City OF BETHLEHEM

BUREAU OF PLANNING AND ZONING

RE: (19-007LD&S) – #19050008 – LVIP VII -Lot 62- 2675 Commerce Center Blvd. – LAND DEVELOPMENT PLAN, Ward 17, Zoned IN, Plans dated May 10, 2019 and revised September 13, 2019.

CONSTRUCTION STANDARD NO.1

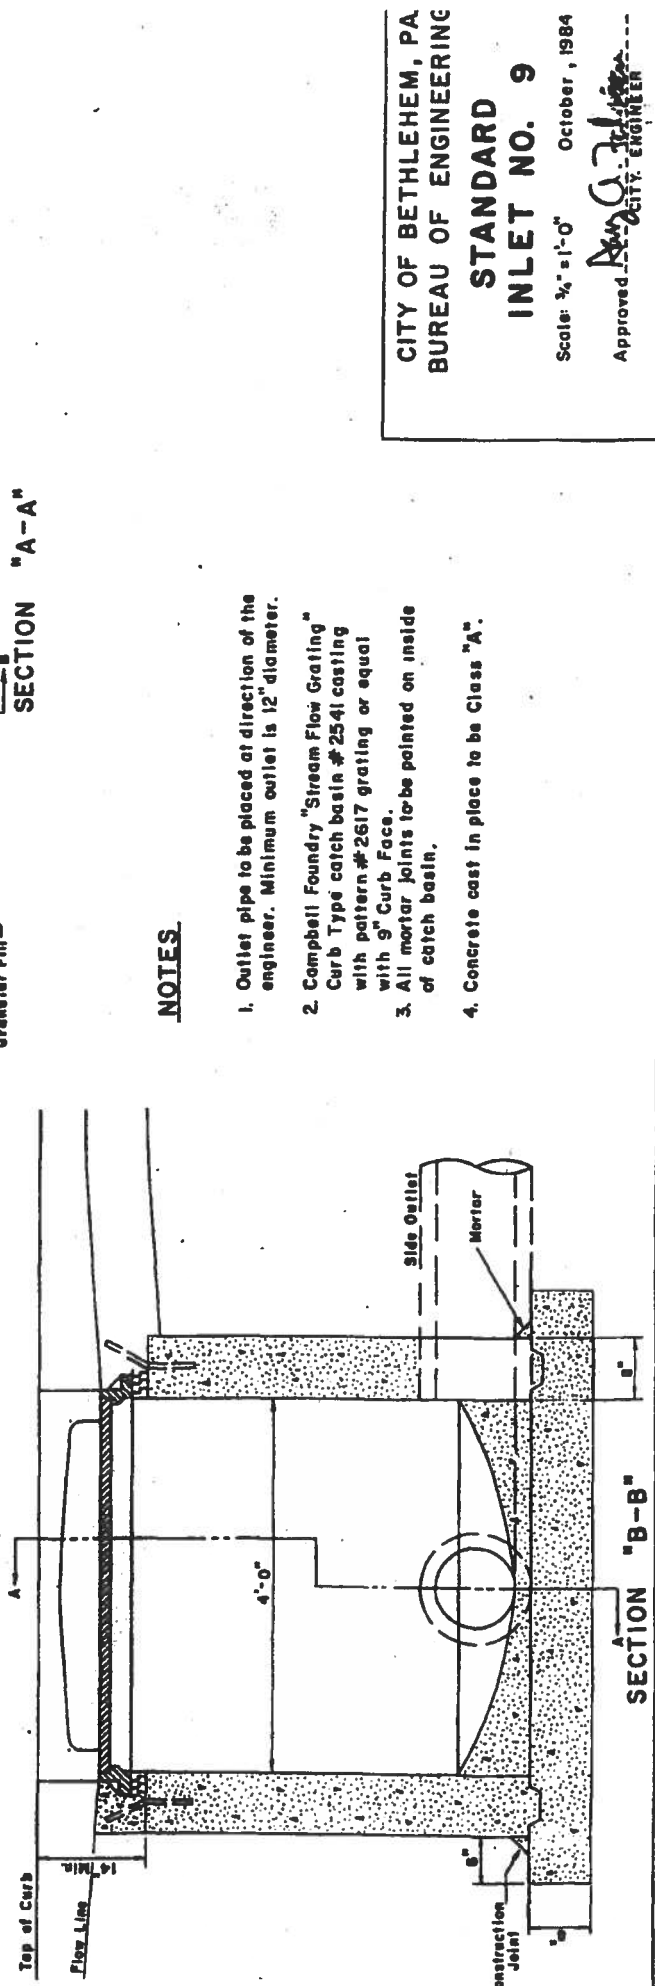
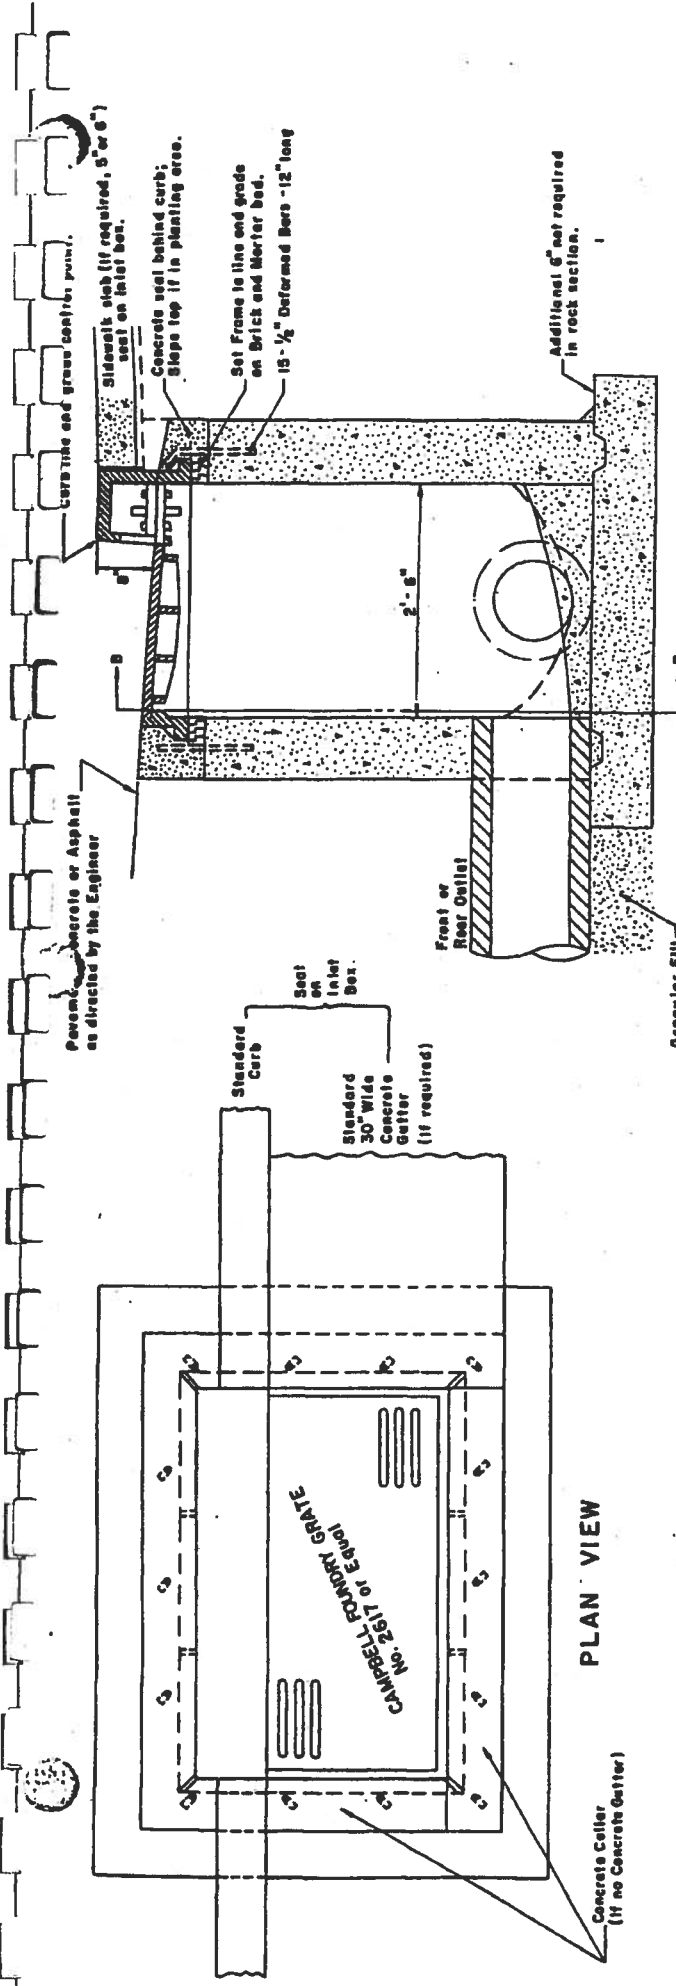
1. The Erosion and Sediment Control Plan, dated May 2019, and last revised September 2019, shall be reviewed by DEP and a copy of the amended permit shall be submitted to the City.
2. A detail for City standard curb shall be added to sheet 6 of 17. The current detail does not meet City Standards. Please see the attached detail.
3. The Engineer's Opinion of Probable Cost shall be updated to include a line item for Lot Monumentation/Iron Pins as well as a line item for the 2 relocated street lights on Commerce Center Blvd. Please submit an EXCEL file of the updated estimate.

CITY OF BETHLEHEM, PA
 BUREAU OF ENGINEERING
STANDARD
INLET NO. 9
 Scale: 3/4" = 1'-0" October, 1984
 Approved: *[Signature]*
 CITY ENGINEER

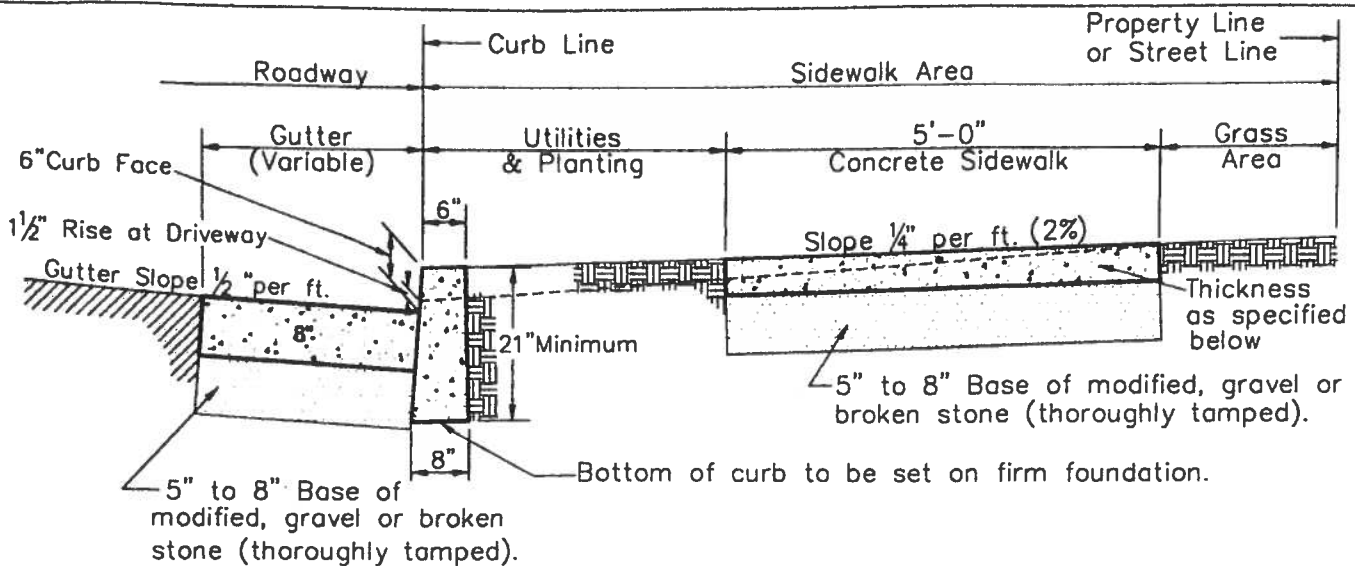
1. In order to convert the existing inlet at the proposed eastern driveway to an M-top it shall be noted that the existing inlet box is not a standard size, therefore the new M-top would need to be upsized in order to fit on the existing #9 box. In our experience, a standard 2' x 4' top will not bear properly on all sides of the box. The box may need to be modified to accommodate a standard M-top. This should be noted on the plans. East Jordan Iron Works does supply an oversized M-top inlet that will accommodate the oversized box.
2. Sheet 17 shall include a detail of Inlet-13. This shall be a City standard #9 inlet and a sump with snout shall be incorporated into the design. A detail of the City standard #9 inlet is attached.
